Your Ref
WA/72/18/HH
Our Ref
PLAN-024202
Date
07/09/2018

Proposal: Single storey extension & detached annexe
Site: Falling Foss, West Walberton Lane, Walberton, BN18 0QS.
WA/72/18/HH

Due to surface water inundation issues in the Lidsey Catchment "The applicant is advised to adopt, where appropriate, the measures in the table "Practical measures to reduce the potential impacts of development".

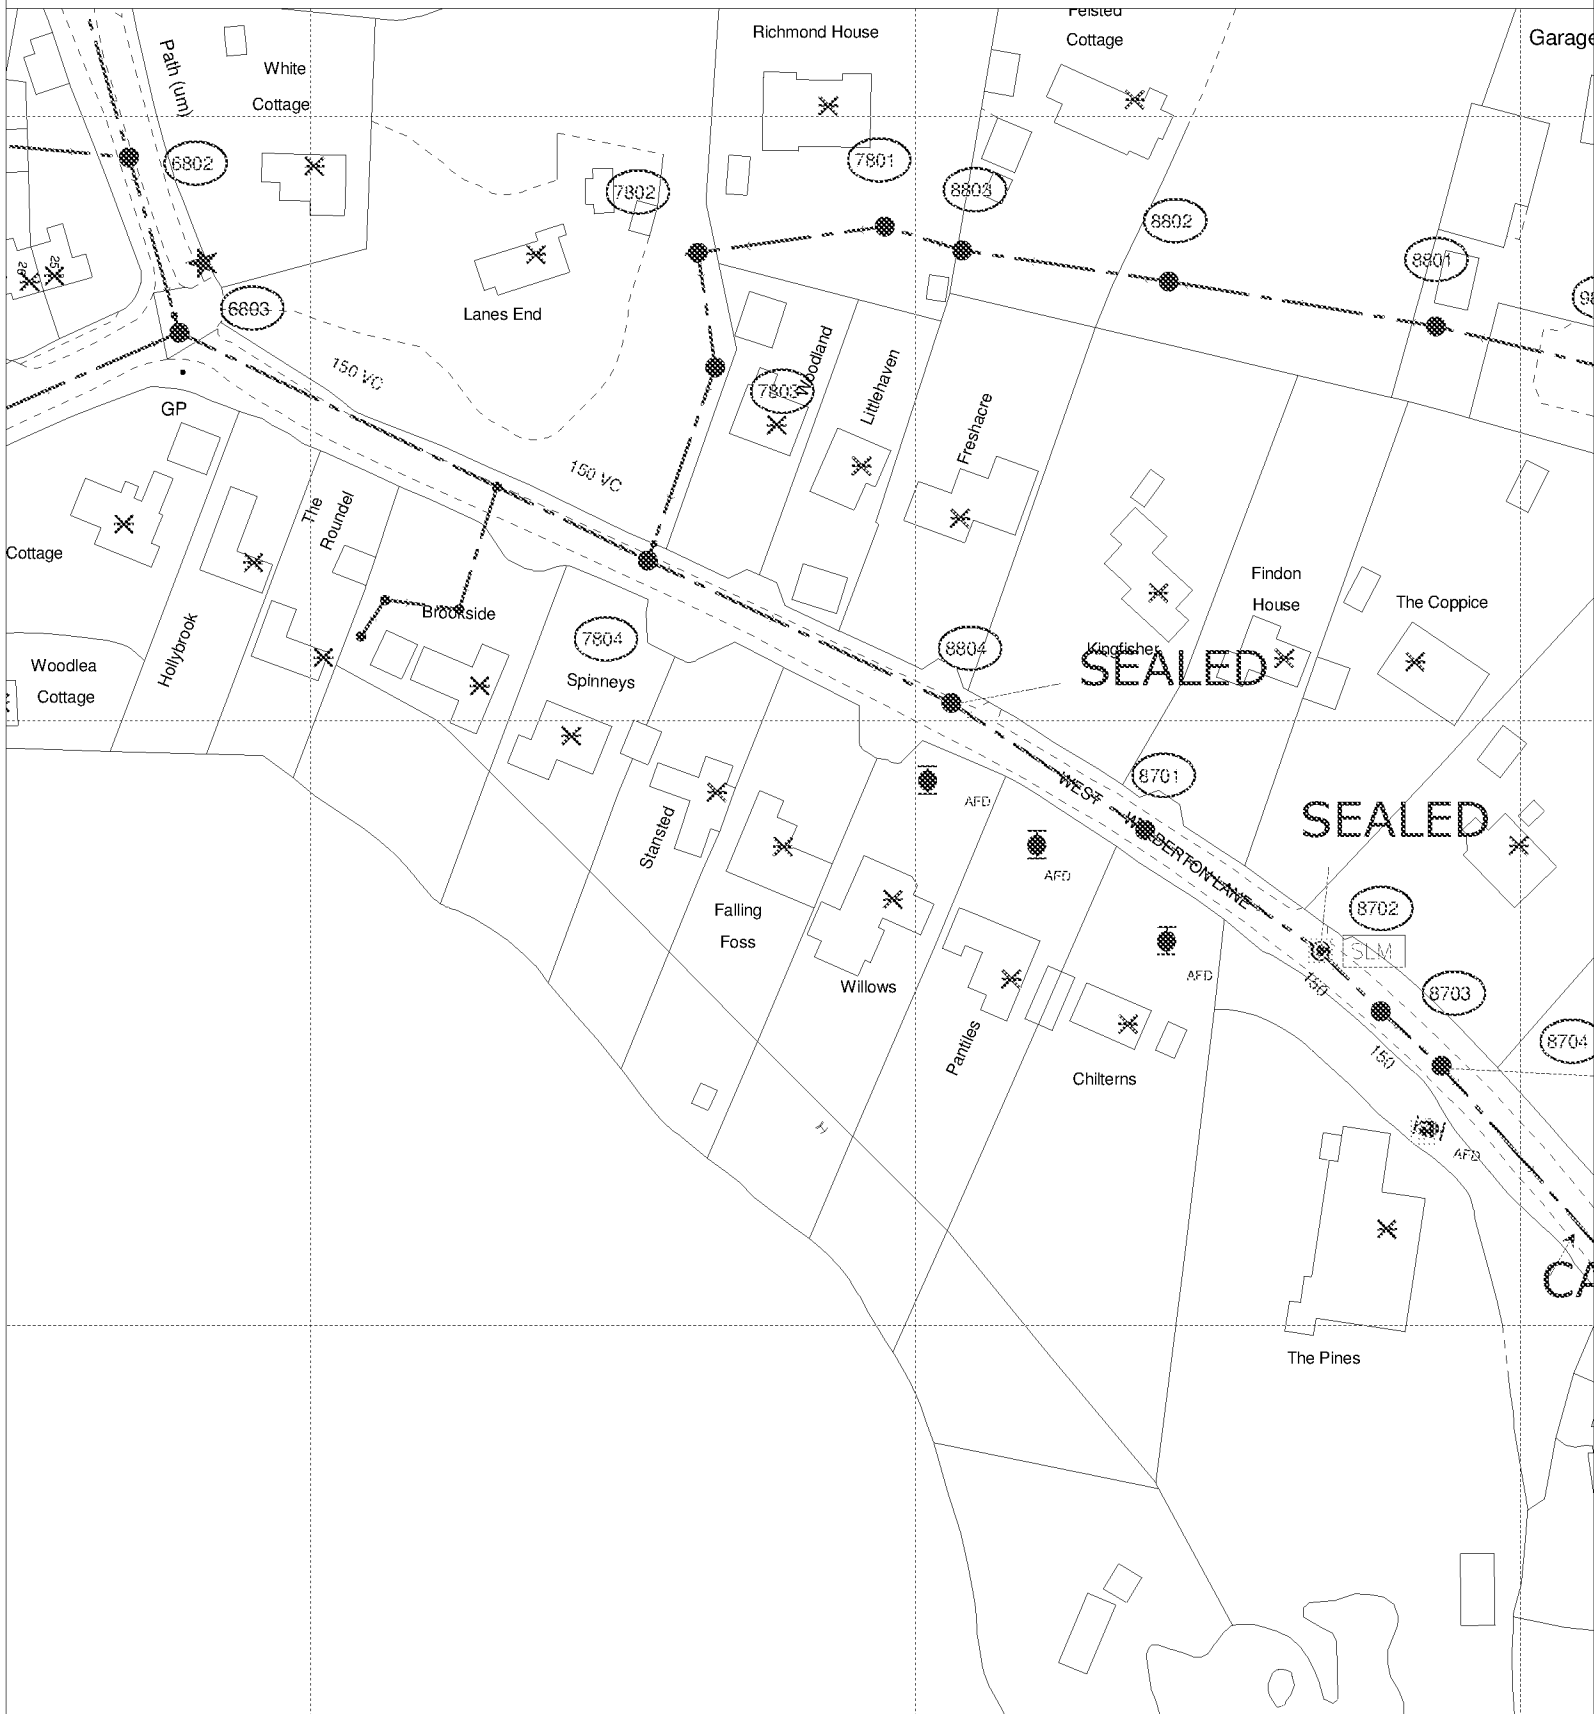
Developer should look to protect the public sewerage system from inundation and infiltration, which contribute to flooding in unfavourable conditions.
